STAFF REPORT

SUBJECT: Windrow No. 4
FP-2026-0028

LOCATION: Generally located at the NEC of S. Linder Road and W. Amity Road in the SW 1/4 of Section 25, T.3N., R.1W.

Final Plat consisting of sixty-six (66) building lots and thirteen (13) common lots on 13.34 acres of land in the R-8 zoning district for the fourth phase of Windrow Subdivision.

B. Final Plat (dated: 8/26/26)

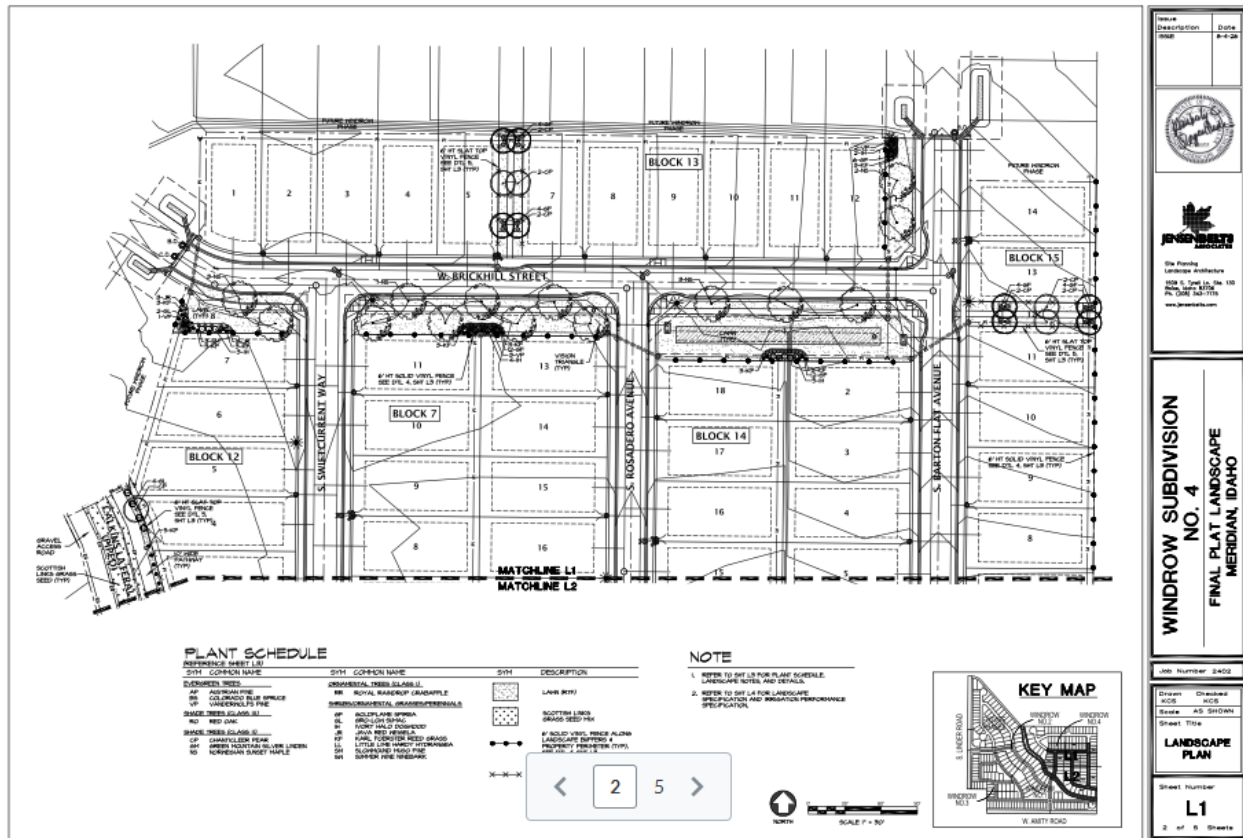
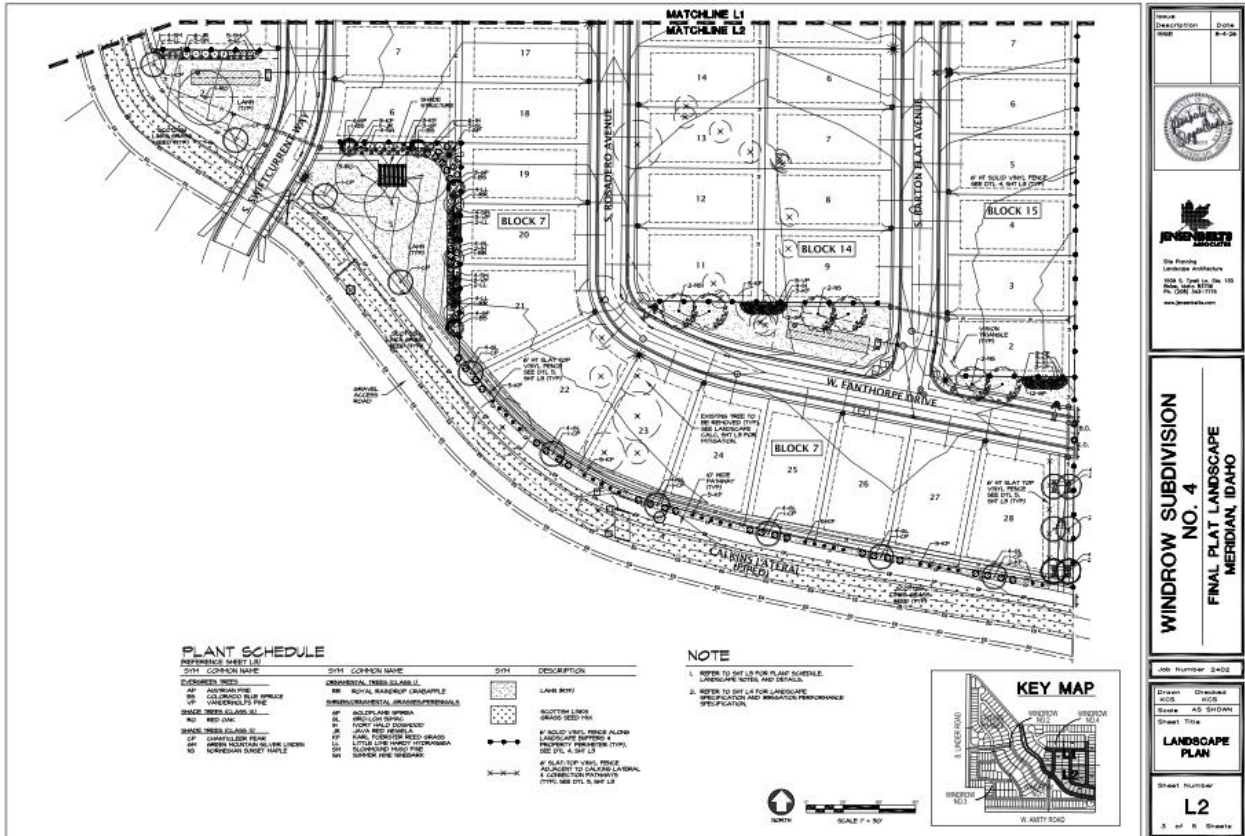
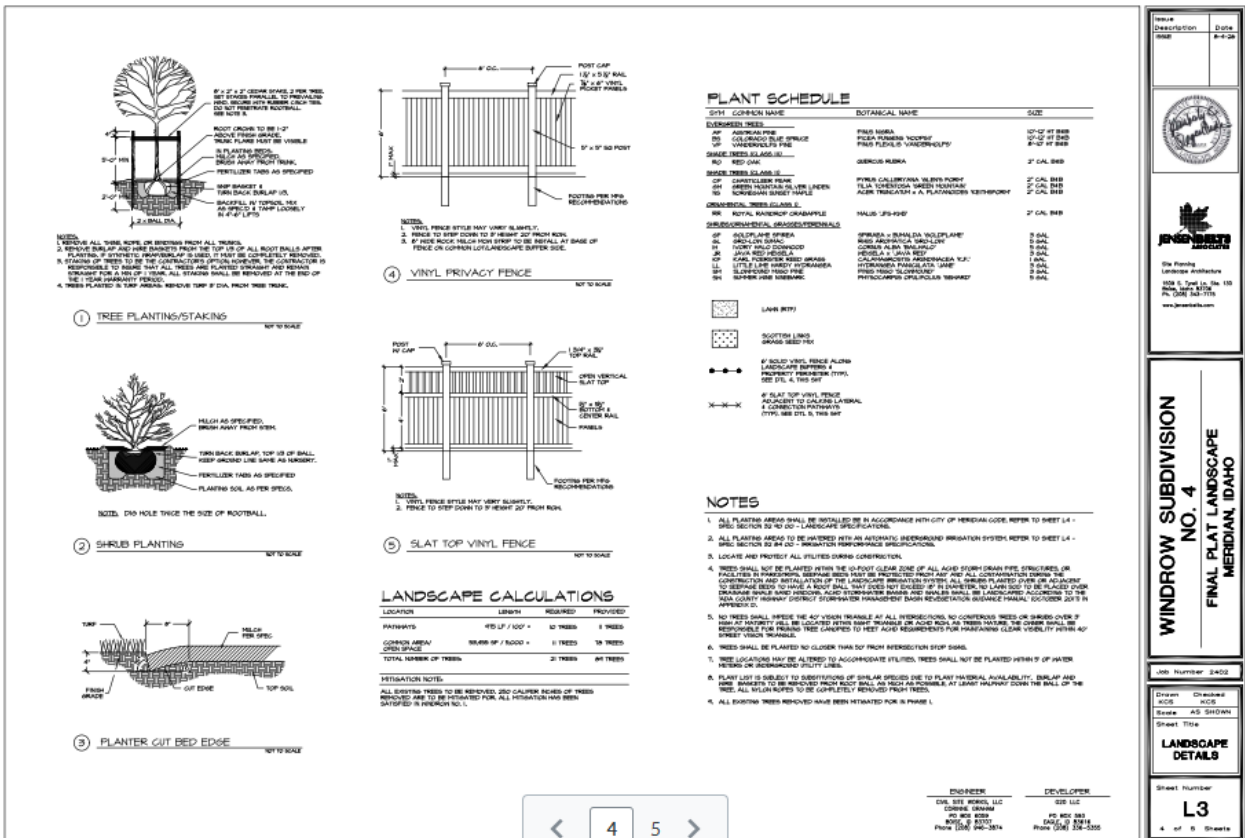
3. Prior to submittal for the City Engineer's signature, have the Certificate of Owners and the accompanying acknowledgement signed and notarized.
4. The final plat prepared by Civil Site Works, dated: 11/2/2023, included in Section V.B shall be revised as follows:

- a. Note #6: Include the recorded instrument number for the ACHD license agreement.
 - b. Note #13: Include the recorded instrument number of the ACHD sidewalk easement.

- c. Note #14: Include the recorded instrument number of the City of Meridian Pathway Easement.
 - d. The plat references Note #15; however, there is not a note 15 listed on page 2. Include note 15 or revise the plat with the correct note reference.

A copy of the revised plat shall be submitted with the final plat for City Engineer signature.
